LAKE HAVASU CITY, ARIZONA  
ADMINISTRATIVE SERVICES DEPARTMENT  
♦ PROCUREMENT ♦

**INVITATION TO BID**  
**PORT DRIVE AND QUEEN'S BAY LIFT STATION UPGRADES**  
**PROJECT NO. B25-PW-107027-028-500661**  
**ADDENDUM NO. 3**  
**MAY 23, 2025**

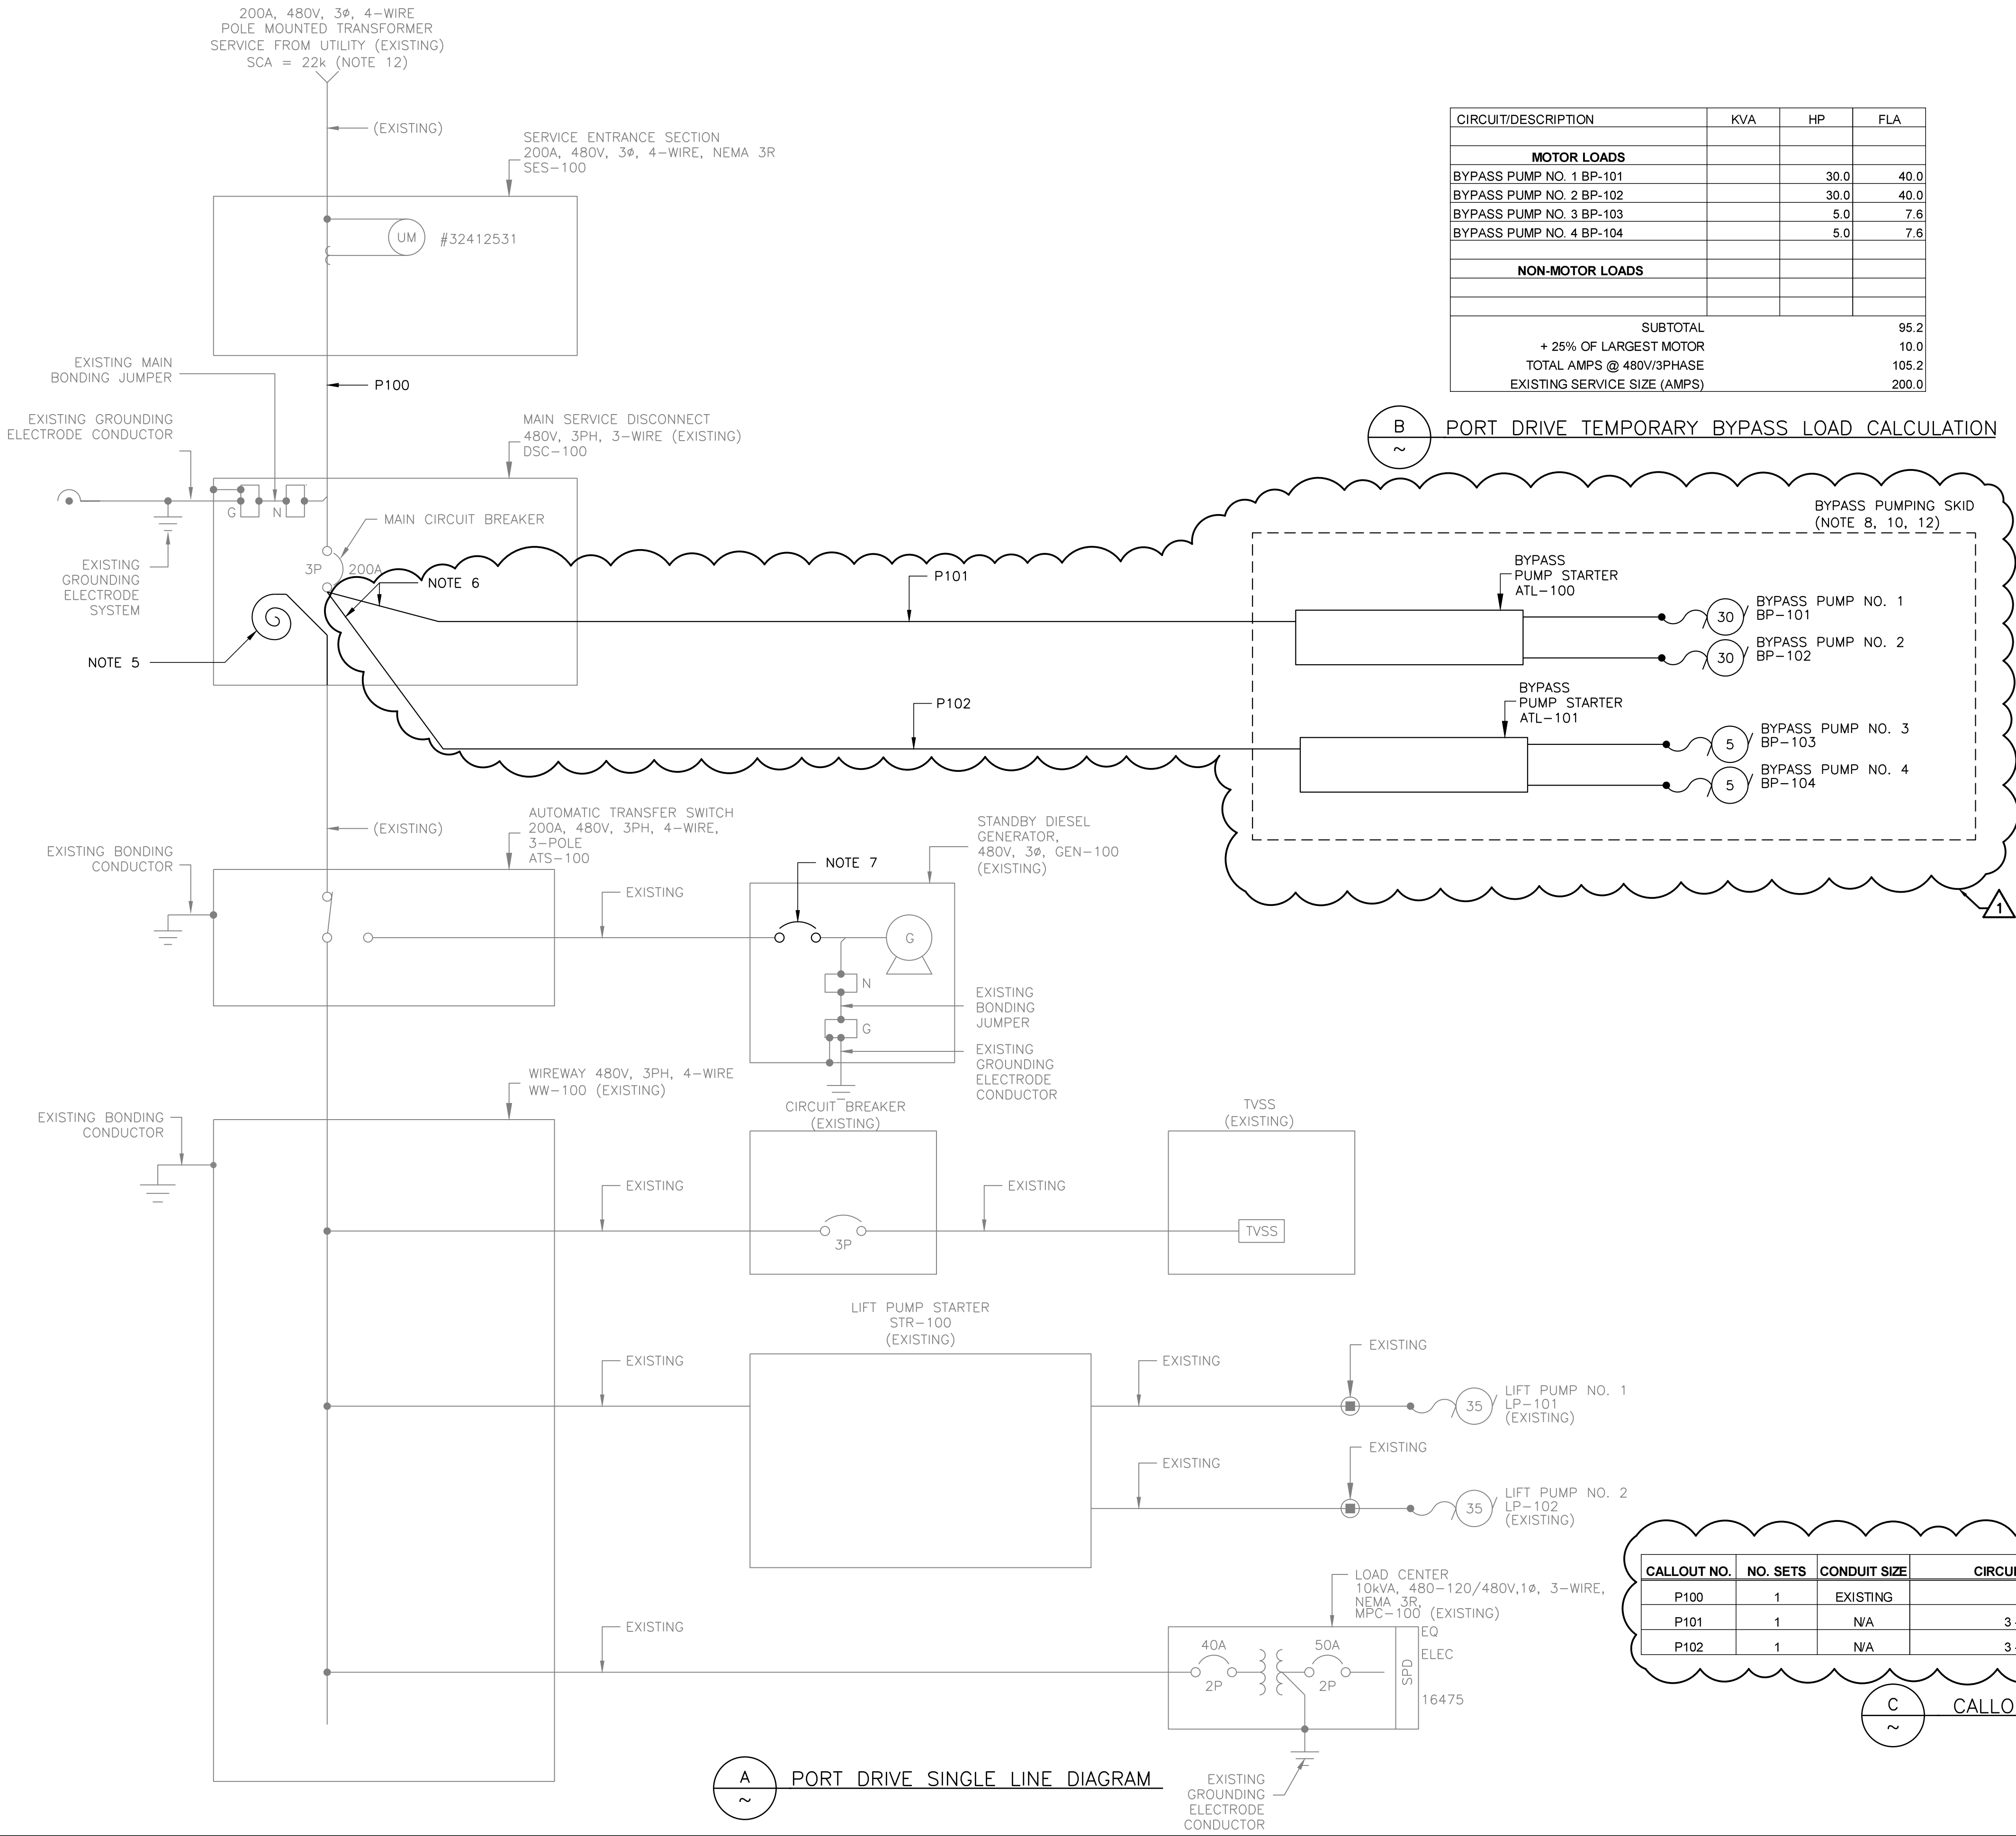
**Question 20:** What is the availability of power at each site?

COPYRIGHT © 2025				
Checked	AGA			
Drawn	EMB			
Design	EMB			
Date	05/21/2025			
Revision Note	ADDENDUM 3 - TWO ELECTRIC PUMPS TO BE PROVIDED PER BYPASS SYSTEM.			
Rev No	1

**Answer 18:** The Contractor may utilize the existing electrical service (with modifications) to run the electric bypass pumps only. All other power needs by the Contractor during construction are to be provided by the Contractor at their expense.

**Answer 20:** See sheets E-02P and E-02Q in the attached revised plans.

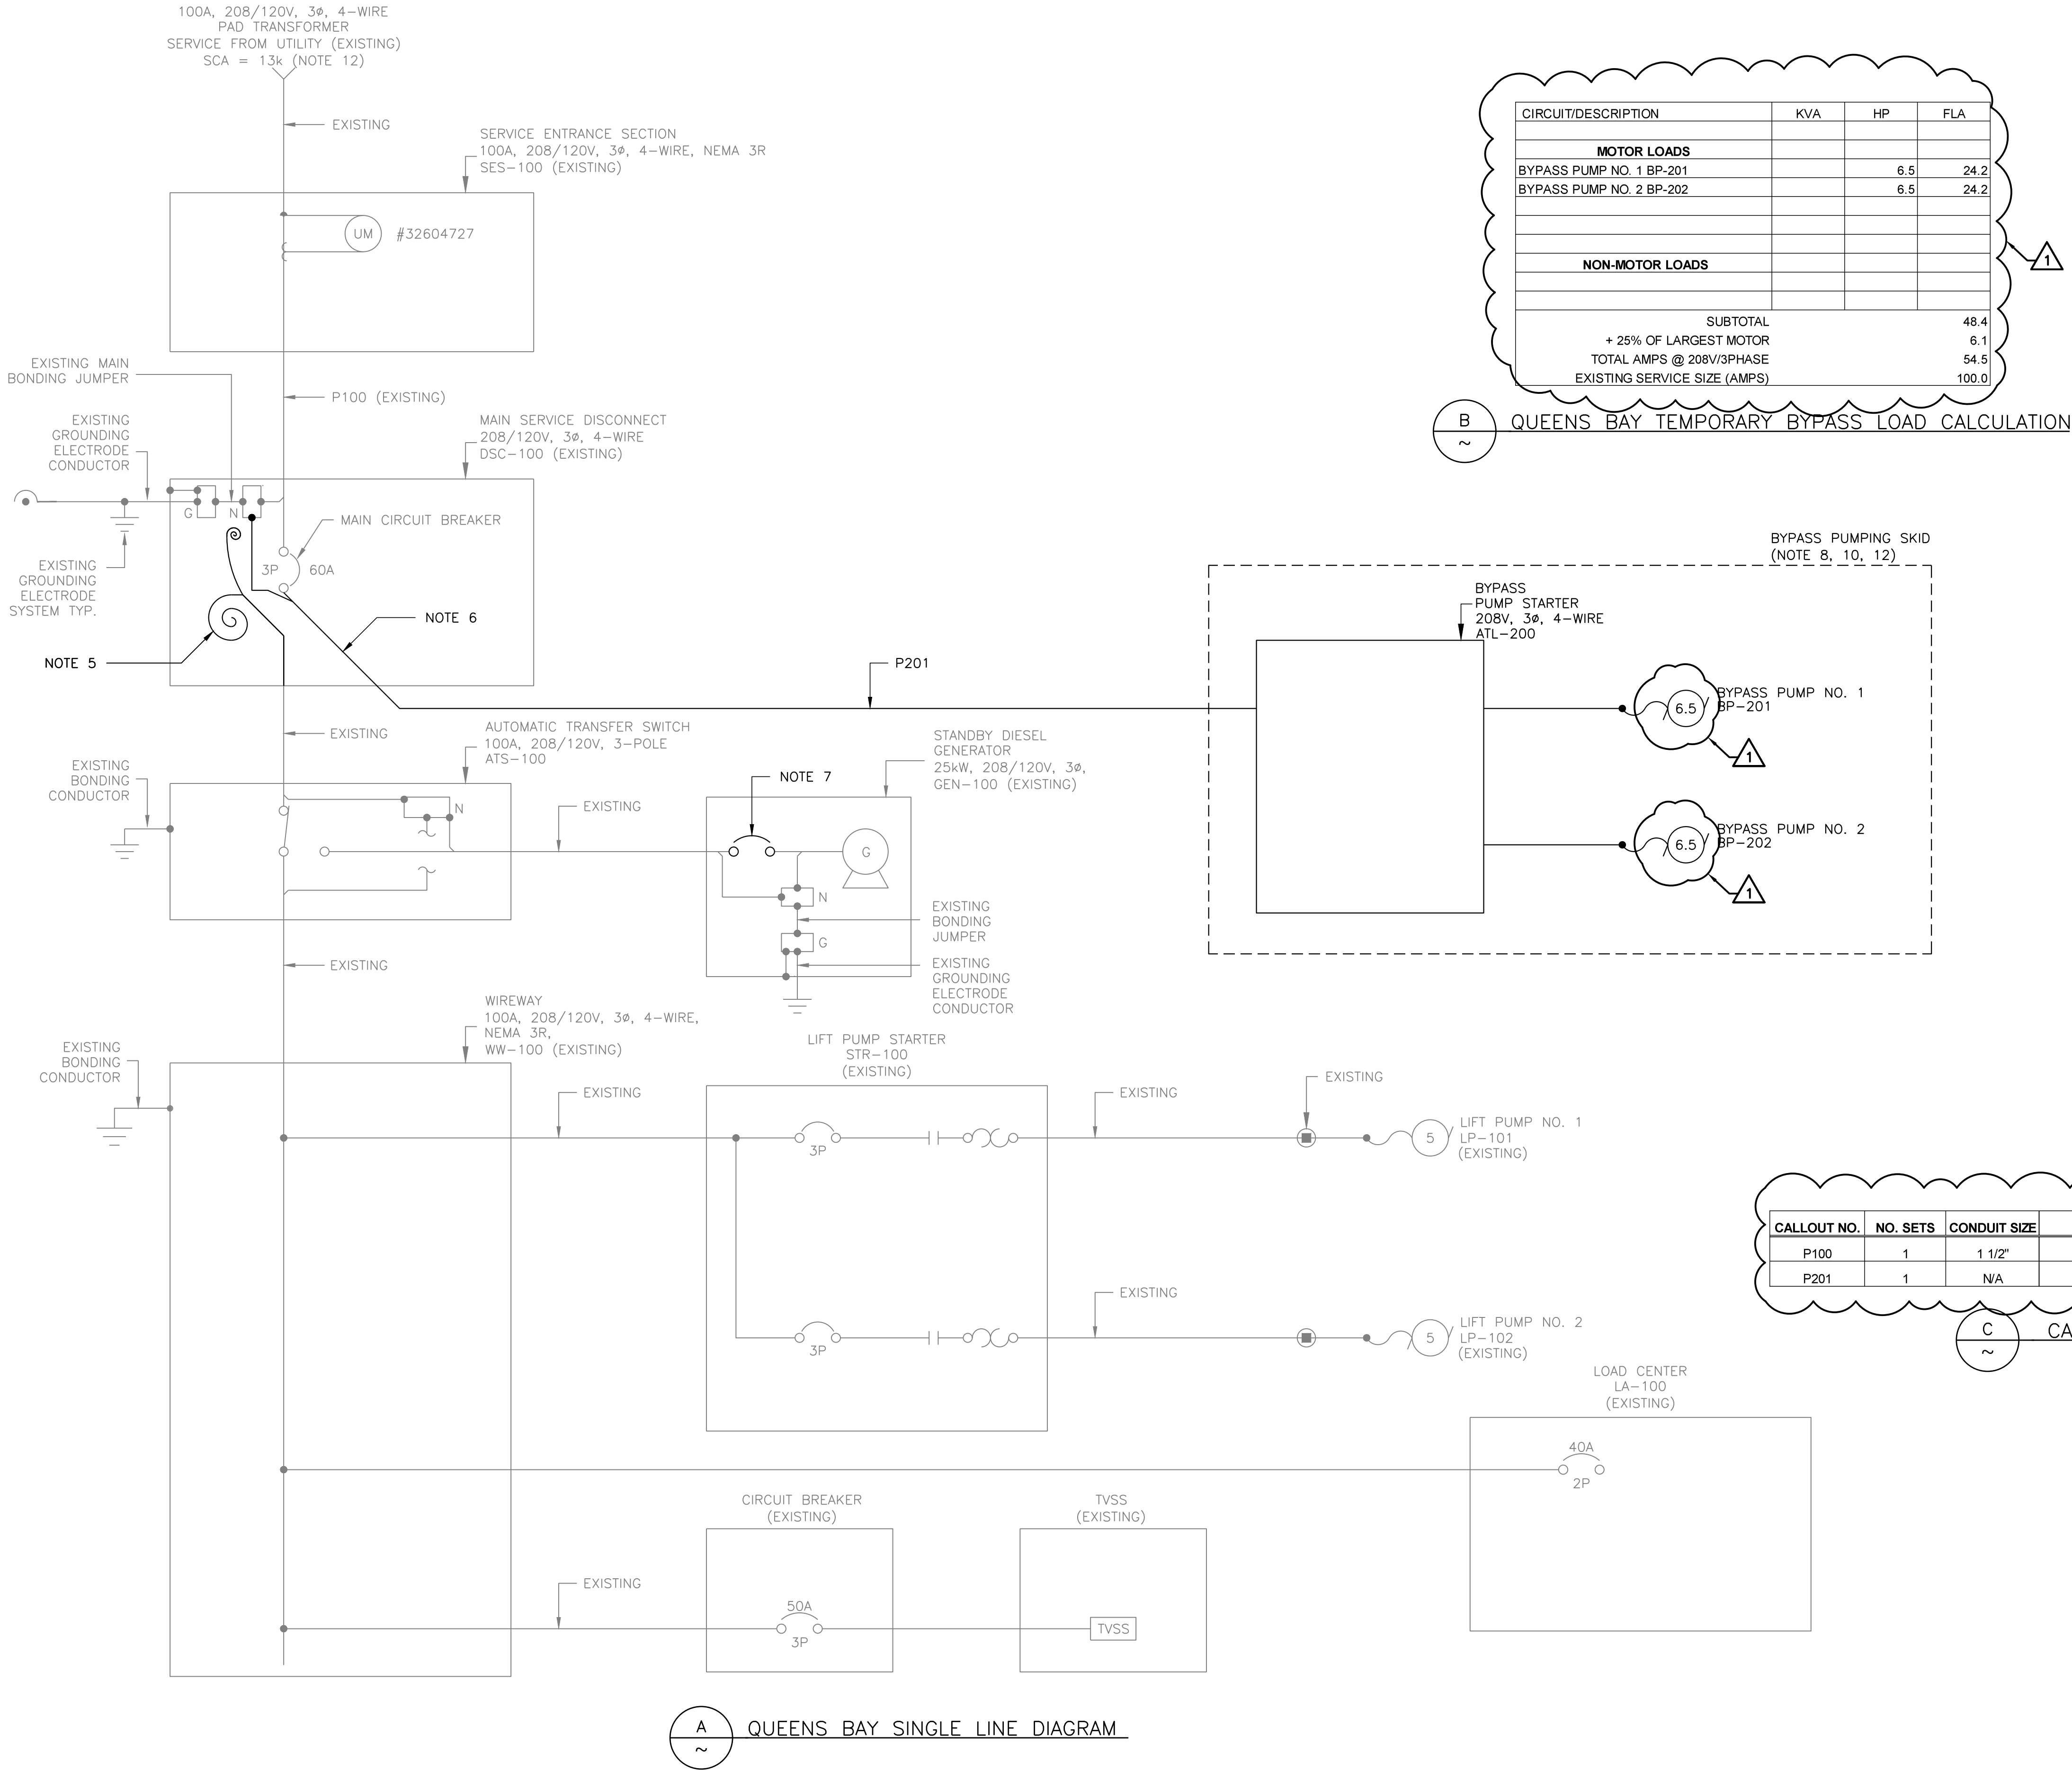
Checked	AGA				
Drawn	EMB				
Design	EMB				
Date	05/21/2025				
Revision Note	ADDENDUM 3 - TWO ELECTRIC PUMPS TO BE PROVIDED PER BYPASS SYSTEM.				
Rev No	1
